NOTICE OF PUBLIC HEARING
Minor Variance

APPLICATION NO.:	A-25:169	SUBJECT PROPERTY:	29 Berry Hill Avenue, Flamborough
ZONE:	'P6' (Conservation / Hazard Land - Rural Zone)	ZONING BY-LAW:	Hamilton Zoning By-law 05-200, as Amended by By-law 15-173

RE: ZONING BYLAW COMPLIANCE REVIEW – IN SUPPORT OF A MINOR VARIANCE APPLICATION
PRESENT ZONING: Conservation / Hazard Land Rural (P6) Zone
ZONING BY-LAW: City of Hamilton Zoning By-law 05-200
ADDRESS: 29 Berry Hill Avenue, Flamborough

PARTIAL SITE PLAN - A
SCALE = 1:200

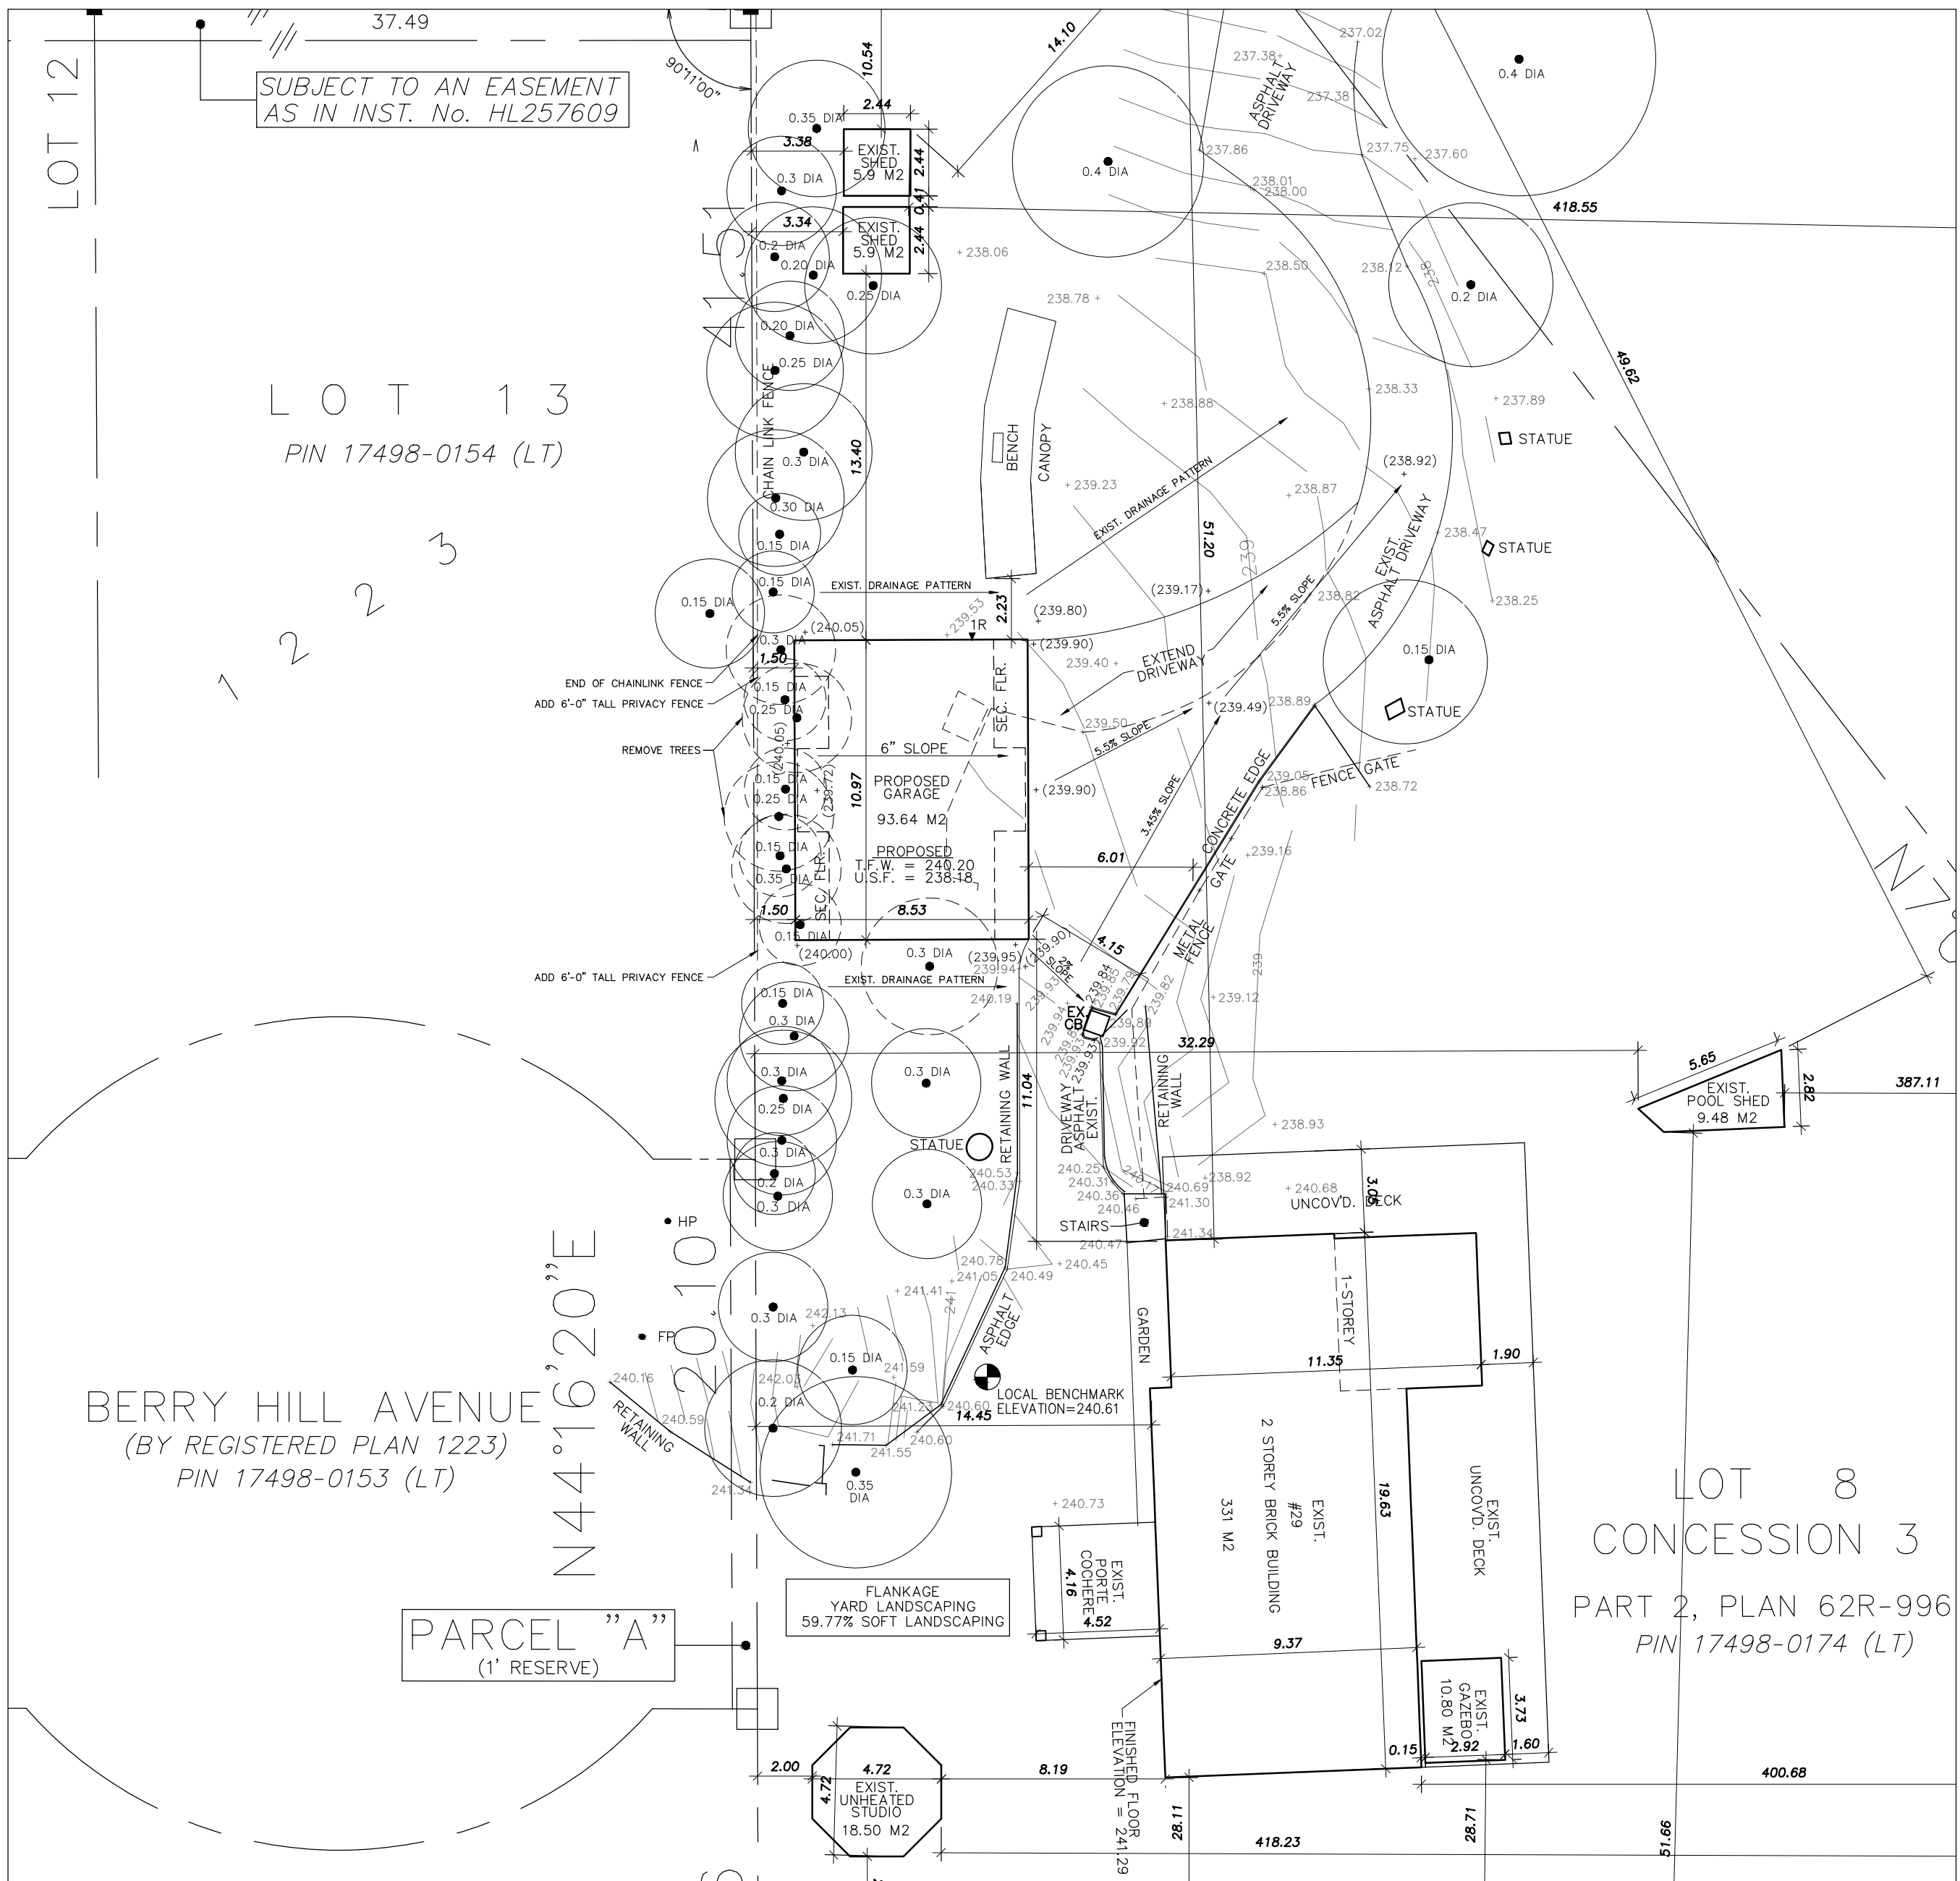
i) Building Setback from a Rear Lot Line: Minimum 1.2 metre	It appears that the proposed Accessory Building (detached garage) is setback more than 1.2m from the rear lot line.	
	ii) Building Setback from a Side Lot Line: Minimum 1.2 metre	It appears that the proposed Accessory Building (detached garage) is setback more than 1.2m from all side lot lines.	Appears to Conform
	iii) Building Setback from a Flankage Lot Line:	Please see Section 4.8.1.1 d) iii) 2, below.

1. Except as required in a Subsection 4.8.1.1 e), Accessory Buildings shall conform to the regulations for the principal use.		
	2. Notwithstanding Subsection 2. 4.8.1.1 d) iii), where a zone does not contain a Flankage Lot Line requirement, the minimum building setback shall be 1.2 metres. <u>Note:</u> Flankage Yard - shall mean a yard extending from the front yard to the rear yard of a lot along a lot line which abuts a street measured to the nearest part of a building on the lot. The entire northwesterly lot line that abuts and extends along Berry Hill Avenue is considered the Flankage Lot Line. The area between the flankage lot line and principal dwelling is considered the flankage yard.	Based on the submitted Site Plan, the Accessory Building is setback 1.5m from the flankage lot line.	Conforms
Vehicular Access [as per section 4.8.1.1 (e) of Hamilton Zoning By-law 05-200]	Where a vehicular entrance to an Accessory Building faces a street line, the vehicular entrance shall be setback a minimum of 6.0 metres from the street line.	Not Applicable. Access to the proposed detached garage will be at through an existing asphalt driveway that would be extended.	N/A

Minimum Access Driveway Width [as per Section 5.2.4 (b) of Hamilton Zoning By-law 05-200]	The width of any driveway providing access to a parking space shall be a minimum of 2.7 metres.	<i>Existing Condition.</i> As noted in the submitted Site Plan, the access driveway to the site from Dundas Street East is 20' (6.0m) in width.	Conforms <i>(Existing Condition)</i>
Tandem and Stacked Parking Restrictions and Exceptions [as per Section 5.2.4 (c)]	All parking spaces shall have adequate means of ingress and egress to and from the street or laneway without the necessity of moving any other motor vehicle, except:	It appears that the driveway will provide sufficient ingress and egress for the vehicles.	Conforms
